# 1967 Corvette: Service News: Inspection and Realignment of the Energy Absorbing Steering Column

**Date:** February, 1967 - Volume 39 - Number 2

## INSPECTION and REALIGNMENT of the ENERGY ABSORBING STEERING COLUMN—ALL 1967 PASSENGER CARS

The following information on inspection and realignment of the energy absorbing steering column supplements and supersedes the information published in Section 9 of the 1967 (Passenger Car) Chassis Service Manual and the 1967 Corvair Chassis Shop Manual Supplement.

## 1967 CORVETTE STEERING COLUMN REALIGNMENT—FIGURE 6

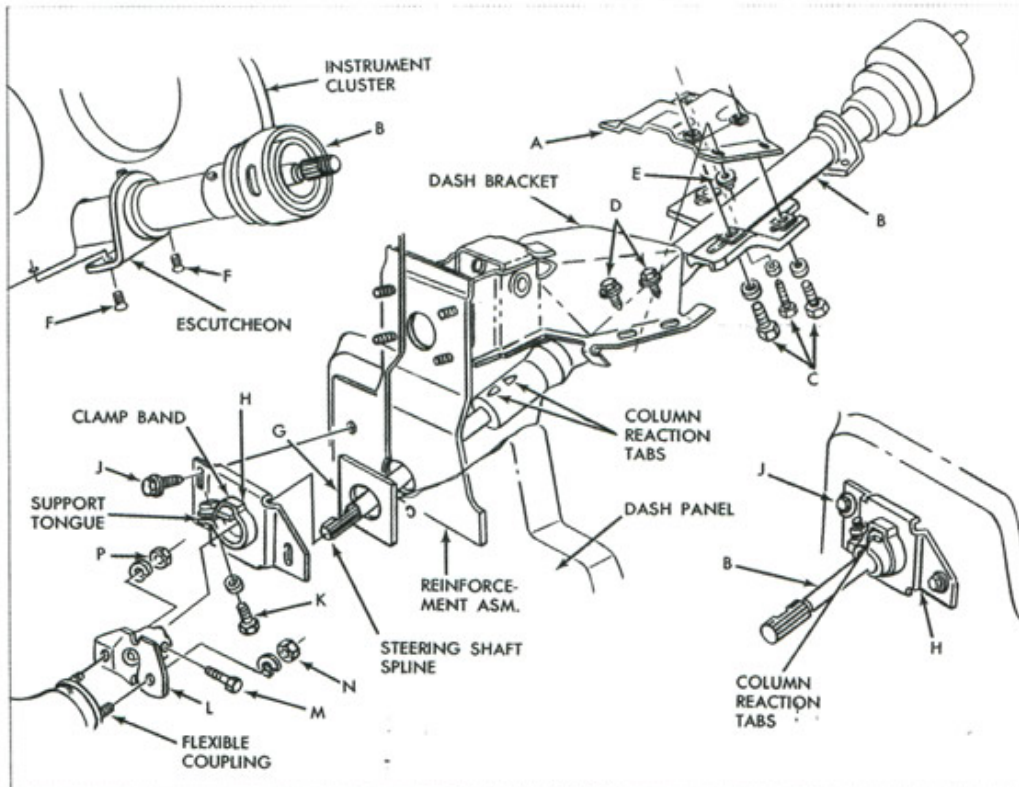
1. Loosen, but do not remove, escutcheon attaching bolts (F).
2. Loosen, but do not remove, three bolts (C) which attach the column (B) to the intermediate bracket (A). Loosen four nuts (E) and bolts (D) which attach the intermediate bracket (A) to the dash bracket.

3. Loosen bolts (J) and (K) which secure the lower column to the toe pan.
4. Loosen flexible coupling flange pinch bolt (M).
5. Check steering column to insure column is loose and can be moved in all directions.

6. Tighten escutcheon attachment bolts (F) to 25 in.-lbs. torque.
7. Adjust column fore or aft to place the clamp band (part of H) between the column reaction tabs (part of B).

8. With the column position defined by flexible coupling and escutcheon, hold the steering column lower support (H) against the front of dash and tighten the wrap-around clamp bolt (K) to 150 in.-lbs. torque.

9. Check bracket (H) to insure that it is not

10. Pull intermediate bracket (A) rearward to accommodate the height differential of the

cluster to instrument panel brace, and tighten three bolts (C) to 20 in.-lbs. torque.

11. With flexible coupling held flat, tighten upper flange pinch bolt (M) to 30 ft.-lbs. torque.
